Access Compliance Report Public Rights-of-Way (Curb Ramps)

Main Street: ORANGE_KNOLL_DR		Cross Street: GATEWAY_DR		Location:	E
ADA ID: RPRK211013171257	Ramp Type: Type 4 - Parallel	Initial Pass/Fail: Pass	Overall Compliance: No	Severity Score:	2
Codes/Mitigation Info/Possible Solution			Field Measurements/Component Compliance

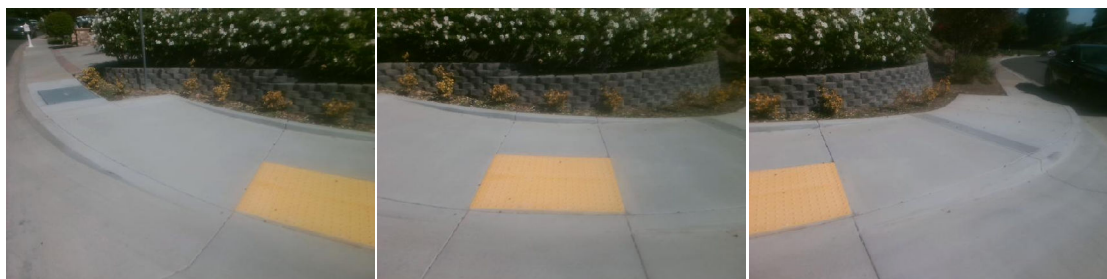
R304.5.3, R304.2.2-Perp, R304.3.2-Para, STD 1115

Remove & Replace Curb Ramp With Two New Directional Ramps or Equivalent.
